**Sec. 4-115. - General exceptions and amendments applicable to all technical codes.**

**Sec. 4-120. - Specific Amendments to the 2021 International Building Code.**

Figure 307.4

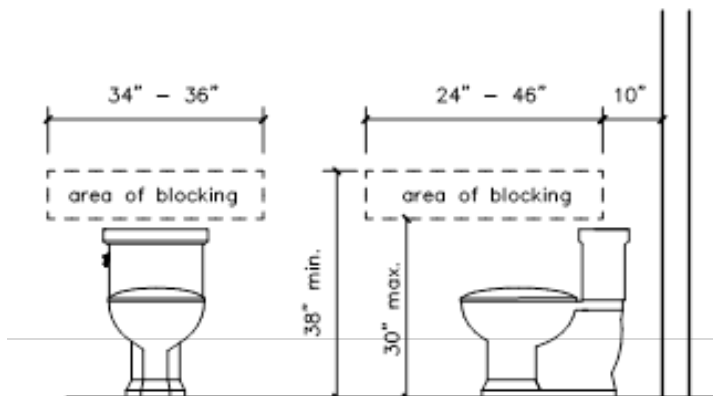
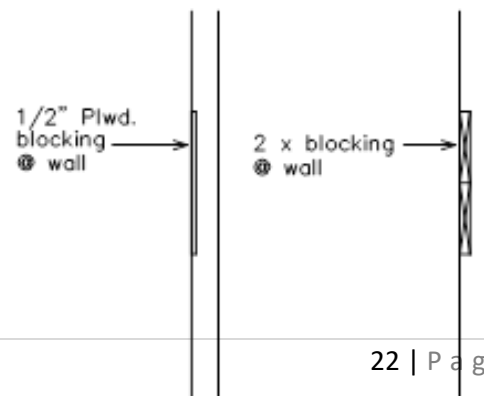
**R307.3 Blocking.** Required at one toilet at grade level. Blocking per Sec. R307.4 and Figure 307.4, shall be installed at rear wall and one wall adjacent to toilet at the lowest living level where a toilet is provided.

**R307.4 Blocking.** Blocking may be 1/2" plywood or equivalent or 2 x solid wood blocking flush with wall.

**Section 503.4.1 Traffic Calming Devices.** shall be amended as follows:

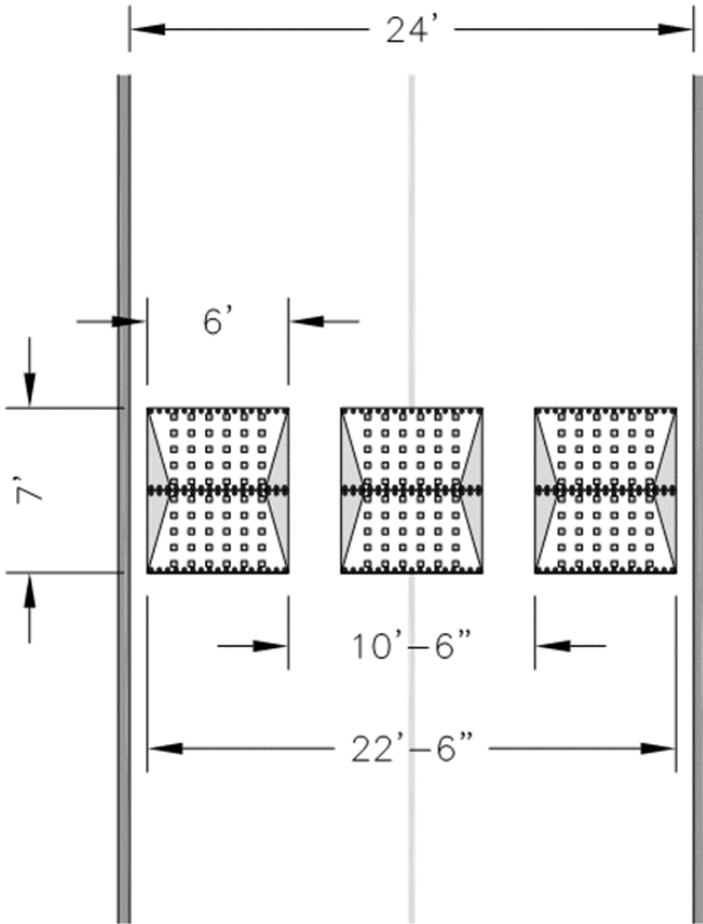
**Section 503.4.1 Speed Cushions** across fire apparatus access roads shall meet the design requirements specified in the Keller Unified Development Code as noted below:

1. Dimensions 3"x6'x7'
2. Entrance and Exit Gradient: 1:15
3. Side Gradient: 1:3
4. Material: Compression molded 100% recycled natural rubber and polyurethane.
5. Advance Notification: Some advance notification of the speed-reducing devices required.
6. Spacing: Minimum spacing of 200 feet between speed cushions.
